SUBJECT: Initial drafts of MIL-DTL-38999/34D with Amendment 1 and MIL-DTL-38999/35D with Amendment 1 (see table below for details).

METRIC
 MIL-DTL-38999/35D
 w/AMENDMENT 1
DRAFT
 SUPERSEDING
 MIL-DTL-38999/35D
 10 July 2008

CONNECTORS, RECEPTACLE, ELECTRICAL, CIRCULAR, BREAKAWAY,
 WALL MOUNTING FLANGE, REMOVABLE CRIMP CONTACTS, SOCKETS,
 SERIES III, SHELL SIZE 25, METRIC

FIGURE 1. Receptacle, classes J, M, **P**, R, T, W, **X** and Z.

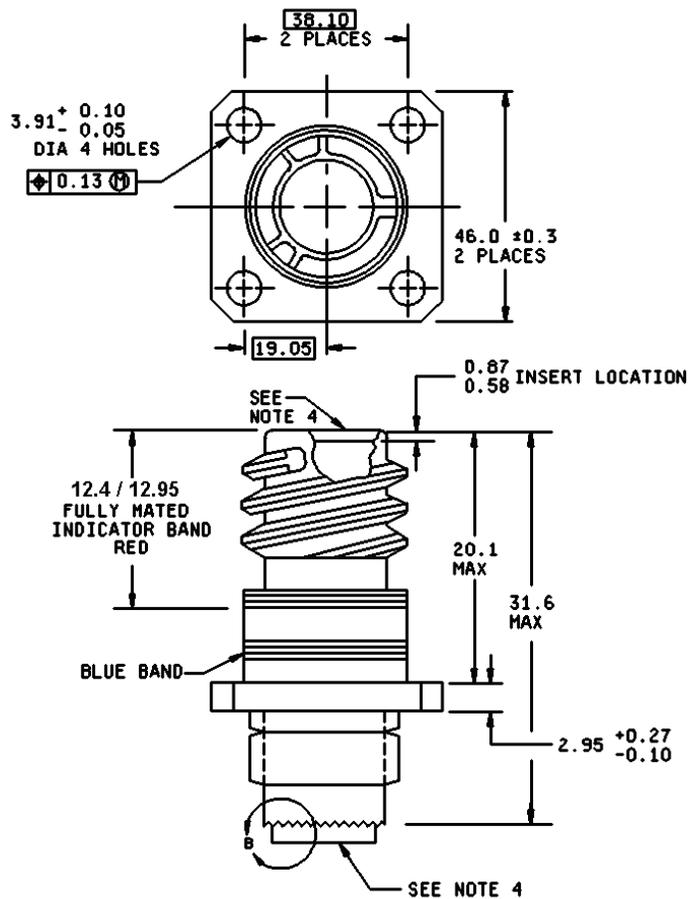
The subject documents have been revised to add notes to Figure 1 in order to provide additional clarification for the red band measurement. Both documents include a proposal to remove class “P” to harmonize the document with the current basic specification, and both documents propose to remove class “X” to harmonize with similar changes in the draft MIL-DTL-38999M w/Amd 1. In addition, the draft MIL-DTL-38999/34D w/Amd 1 includes a proposal to update the external O-ring requirement to harmonize with the requirements in the basic specification. Finally, both documents include editorial changes, including updating the ASSIST website address in the Concluding Material, and updating the sine vibration test procedure from “MIL-STD-202, method 204” to the latest version of the document, “MIL-STD-202-204”, which incorporates the test method number into the document number.

1. Dimensions are in millimeters.
2. Inch equivalents are given for information only.
3. Front or rear panel mounting.
4. For details of connector front and rear configurations, see MIL-DTL-38999.
5. **The specified red band location is measured from the front of the shell to the back end of the red band.**

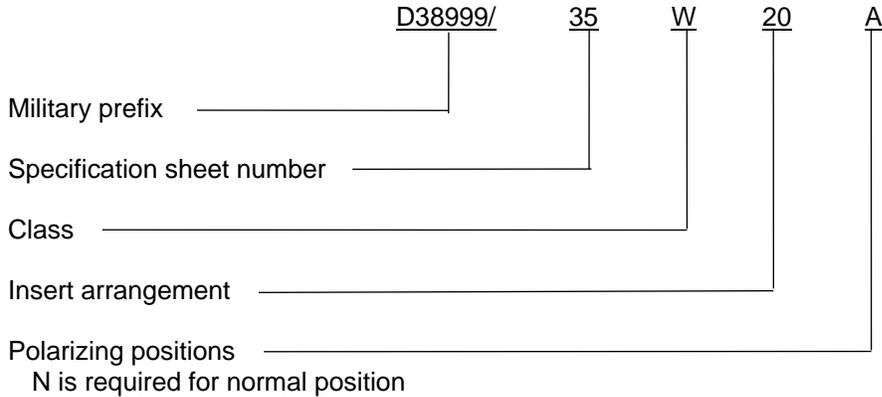
This receptacle ~~is designed for use~~ **mates with the following** lanyard release plugs: ~~and mates with~~ MIL-DTL-38999/29, /30, and /31. It is intended to be used only on stores.
